APPLICATION NO.	FILING DATE	FIRST NAMED INVENTOR	ATTORNEY DOCKET NO.	CONFIRMATION NO.
09/756,288	01/09/2001	Signe Uhre Guldfeldt	P66317US0	5968

Office Action Summary

DETAILED ACTION

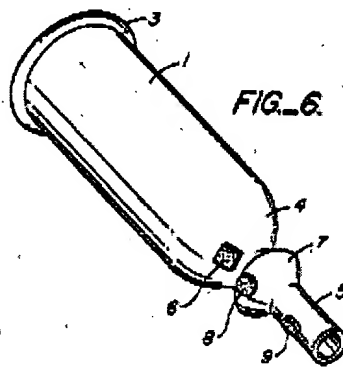
Regarding claim 1, Fajnsztajn teaches an external urinary catheter device (1) for the relief of male urinary incontinence, comprising a contact member (4) which is adapted to be engaged with at least the extreme portion of a penis, an opening formed in a distal end section of the

contact member (4) and positioned substantially opposite the urethral orifice in the position of use, a discharge conduit (5) connected with the opening to provide a sealed urine flow passage extending in a substantial axial direction towards the exterior of the catheter device (1), wherein, an aperture (6) is provided in a distal part of the contact member (4) or in the discharge conduit (5), a membrane (6) is fastened to the surface surrounding said aperture (6), the membrane (6) being capable of selectively passing gases but retaining urine (*see Fig. 6, below*).

Fajnsztajn therefore expressly teaches every element of the claimed invention except for a shield to protect the membrane.

FIG. 1

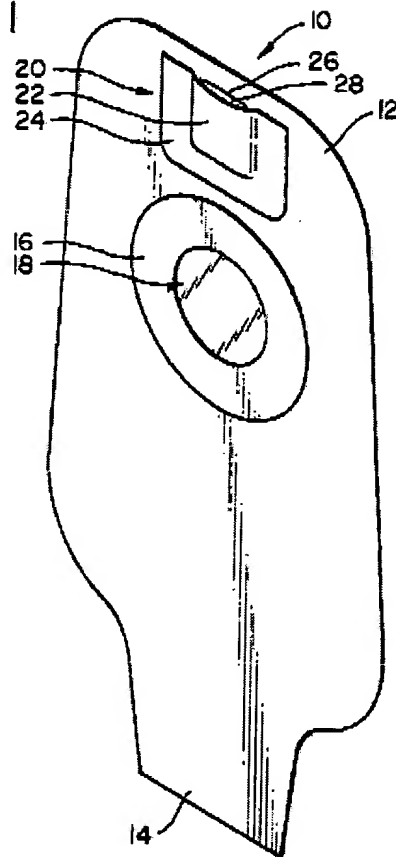
Blanton teaches an ostomy pouch which features a vent (42) covered by a membrane (60) which is protected by a shield (22)(*see Fig. 1, below*).

At the time of the invention, it would have been obvious to one of ordinary skill in the art to combine the shield of ^{Blanton} Leide, Jr. with the urinary drainage device of Fajnsztajn in order to provide a means of protecting and holding the membrane in place.

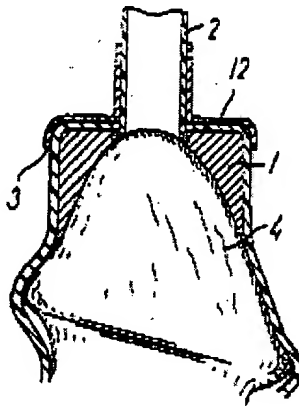
Tanghøj teaches a contact member (1) which is an inner member arrangeable, in a position of use, between the foreskin and the corona of a penis (*see* Fig. 3, below).

At the time of the invention, it would have been obvious to one of ordinary skill in the art to combine the vent of Fajnsztajn and Blanton with the device as taught by Tanghøj in order to provide venting and increased comfort.
